# B I D A D D E N D U M 0 4

**HARRISON RECREATION & COMMUNITY CENTER**

New Construction - Phase 1

**A204**

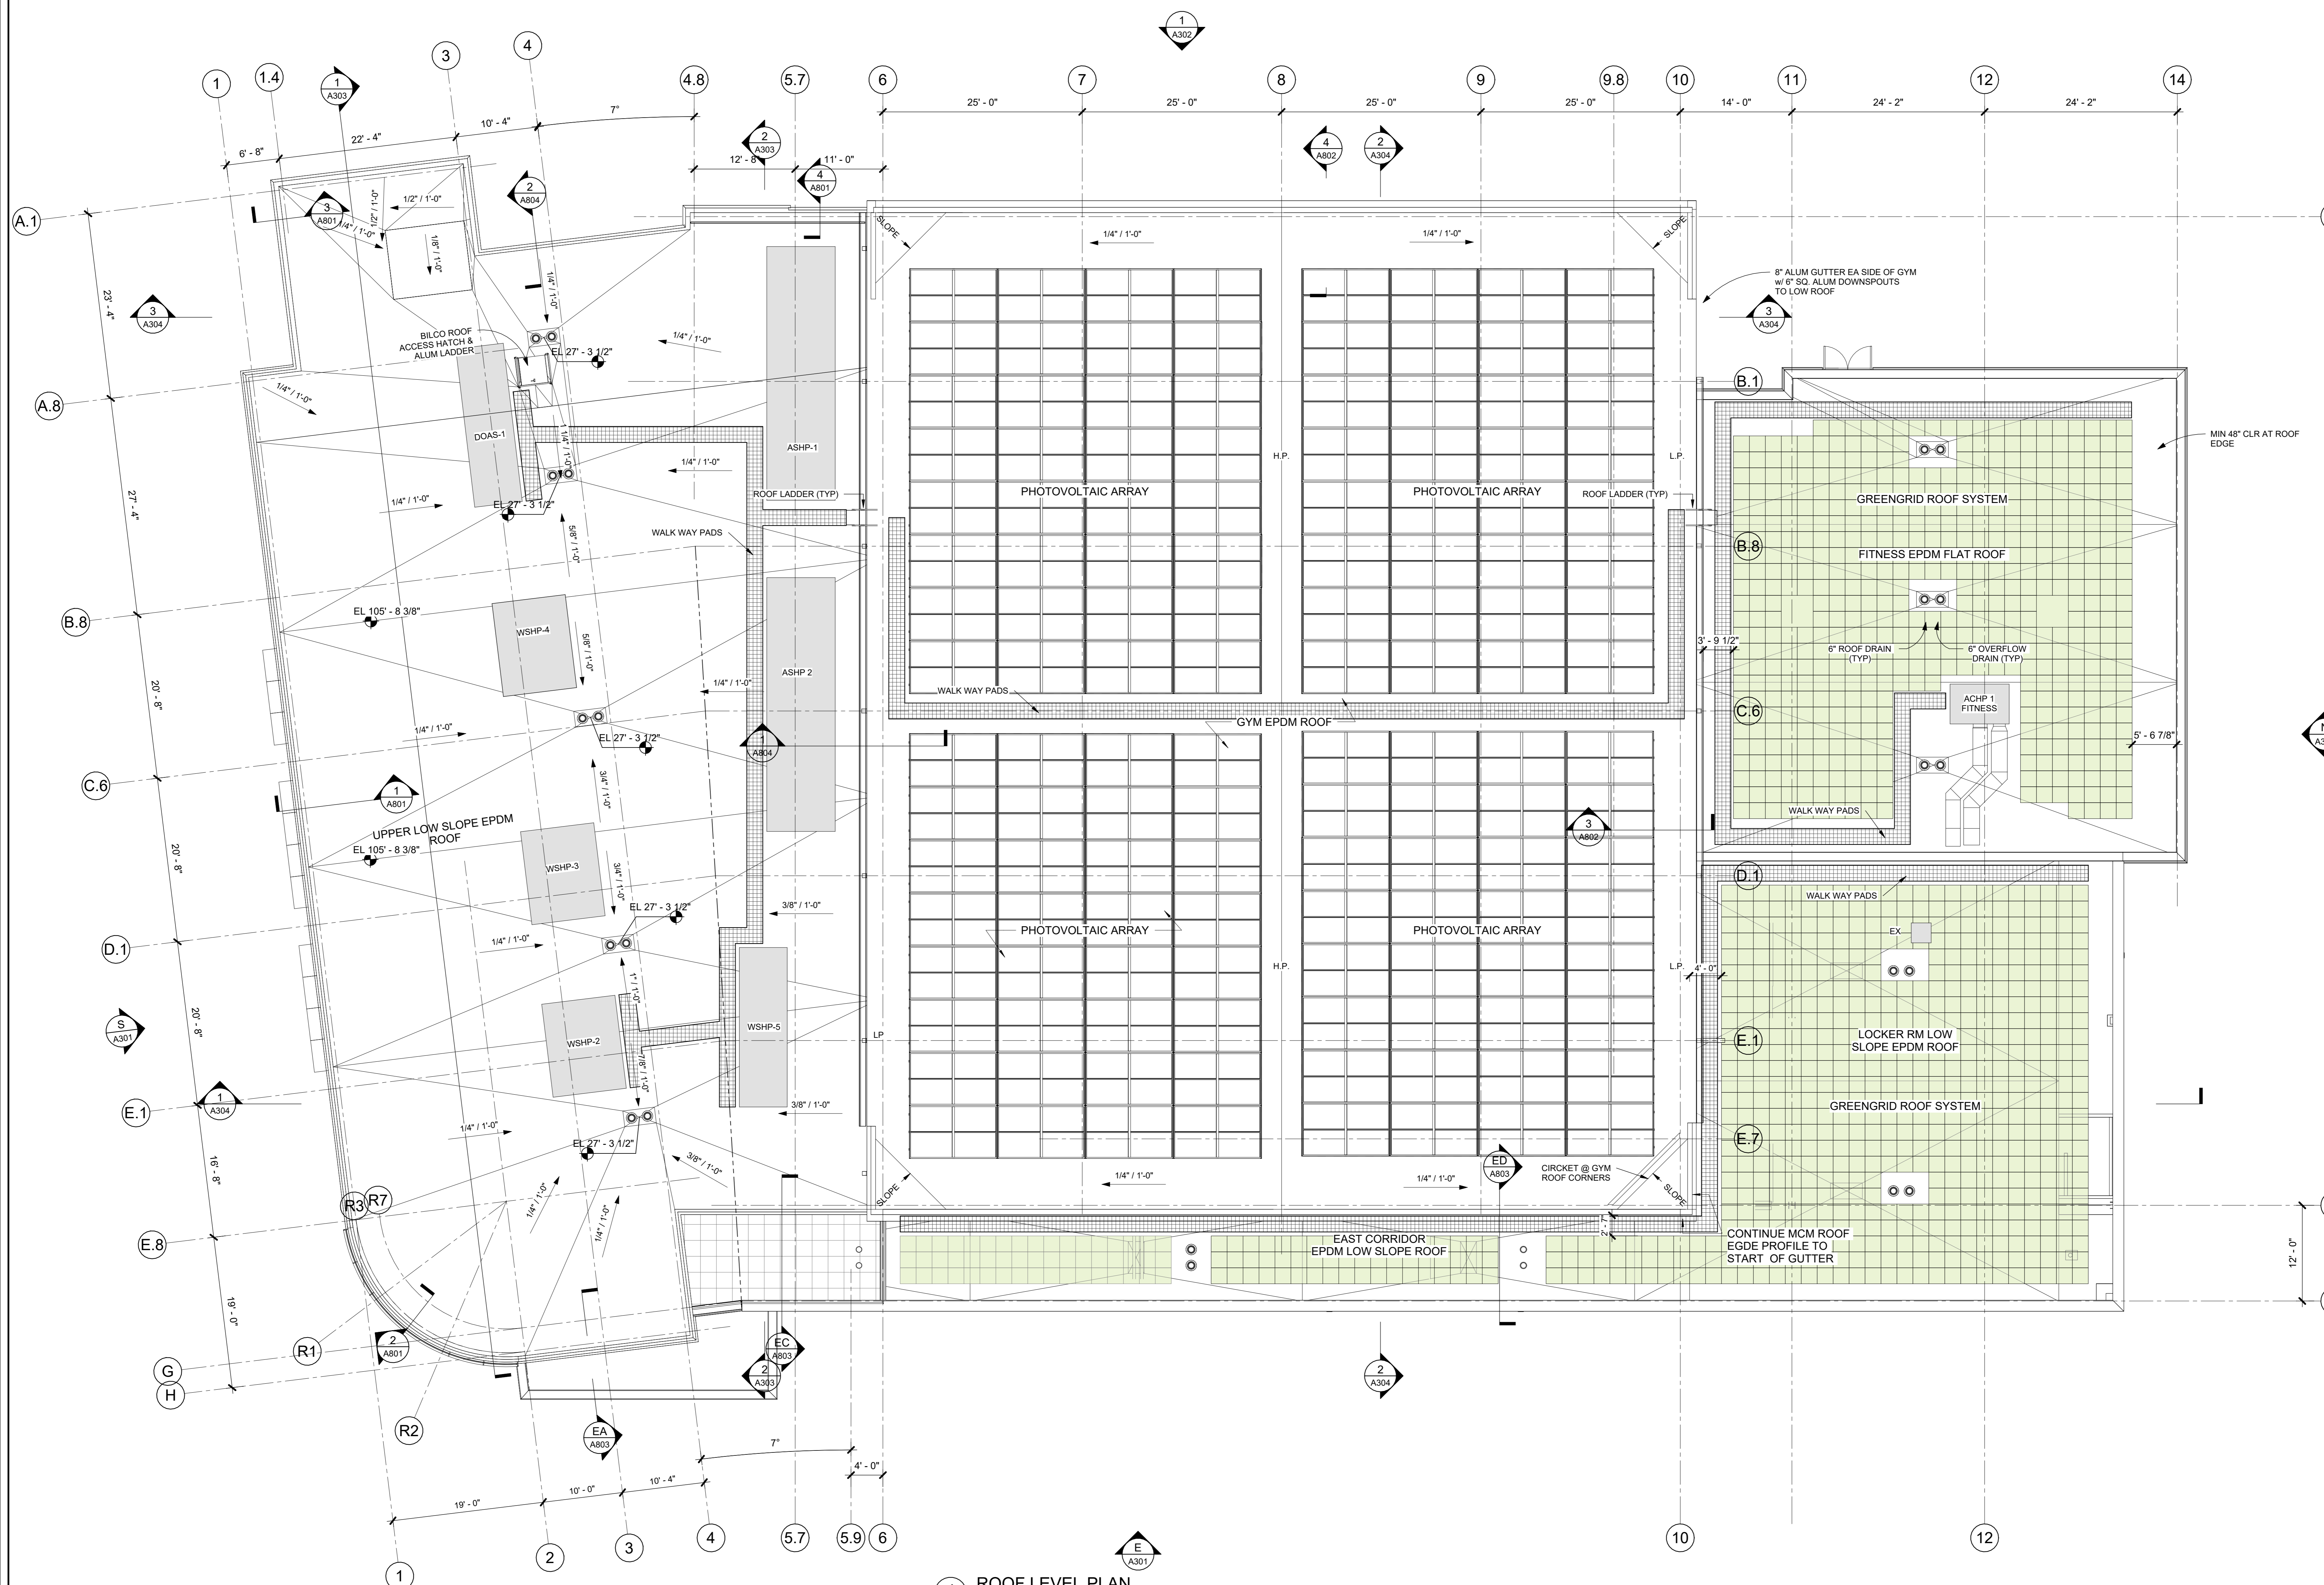
1. Revised Sheet A204 Roof Plan
2. Revision to Drawing E-302, Electrical First Floor Plan: CONTRACTOR SHALL PROVIDE A DUPLEX RECEPTACLE ON THE SOUTHEAST WALL OF THE FITNESS 123 IN FRONT ENTRY DESK FOR POWER LOCKER CHARGING STATION CONNECTION. WIRING SHALL BE 2-#12 AND 1-#12 GND IN 3/4"C. PROVIDE (1) 1P-20A CIRCUIT BREAKER IN PANELBOARD PN1A UTILIZE SPACE #29.

31. Q: Refer to drawing A932, detail # 2 shows walkway pads at roof. However, on drawing A204 walkway pads are not shown anywhere on roof plan. Please provide quantity/ extent for bidding purpose

- A: Walkway pads to be installed at all ladders as shown in detail on A932. Walkway pads will also be required on paths to all the roof top mechanical equipment and at the center of the gym roof to the ladder at the low roof on the north side.
